# UNITED STATES PATENT AND TRADEMARK OFFICE

APPLICATION NO.	FILING DATE	FIRST NAMED INVENTOR	ATTORNEY DOCKET NO.	CONFIRMATION NO.
10/736,618	12/17/2003	Yoshihiro Ohkura	X2007.0147	4069
32172	7590	06/28/2005	EXAMINER	
DICKSTEIN SHAPIRO MORIN & OSHINSKY LLP 1177 AVENUE OF THE AMERICAS (6TH AVENUE) 41 ST FL. NEW YORK, NY 10036-2714			NGUYEN, DILINH P	
			ART UNIT	PAPER NUMBER
			2814

**Office Action Summary**

## DETAILED ACTION

**Fig.1**

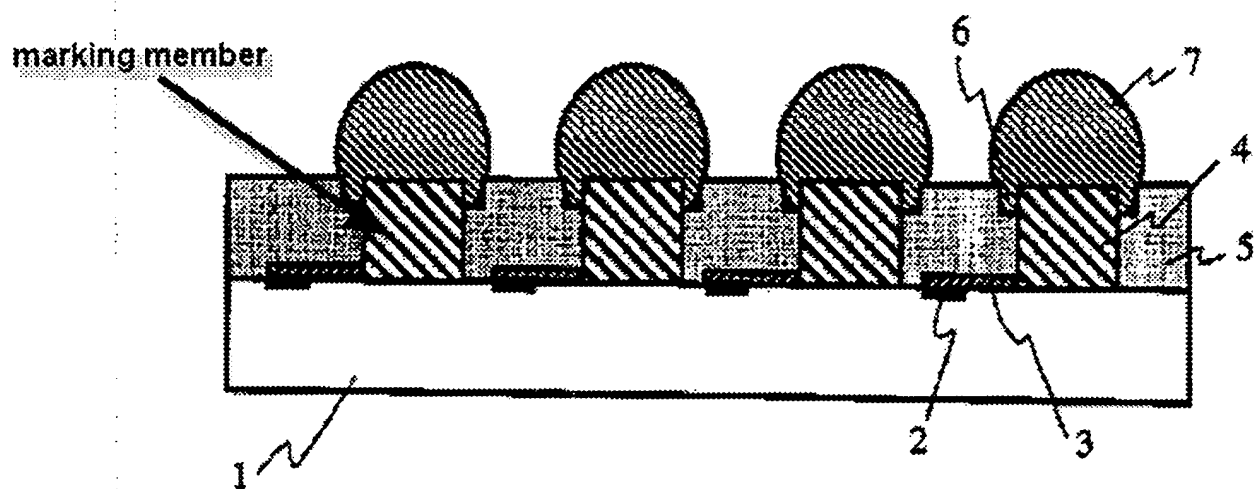
Ohuchi et al. disclose a surface mount chip package incorporating a semiconductor chip having an integrated circuit, comprising: a package housing 5 made of a resin that covers the semiconductor chip 1 while avoiding a plurality of conductors 4 extending from the semiconductor chip 1;

a plurality of external electrodes 7 that are arranged in the package housing 5 in correspondence with a main surface of the semiconductor chip having the integrated circuit and are connected with the plurality of conductors extending from the semiconductor chip; and

at least one marking member that is arranged in the package housing so as to realize a directivity when viewed in a thickness direction of the semiconductor chip (fig. 1, column 2, lines 56 et seq.).

- Regarding claim 2, Ohuchi et al. disclose that an outline shape of the marking member includes at least one linear portion (fig. 1).

- Regarding claim 4, Ohuchi et al. disclose that the copper post serving as the marking member has a square shape (fig. 1).
- Regarding claim 5, Ohuchi et al. disclose that the copper post is covered with a solder layer 7 (fig. 1, column 3, line 35).

- Regarding claim 6, Ohuchi et al. disclose that the marking member has a square shape (fig. 1).
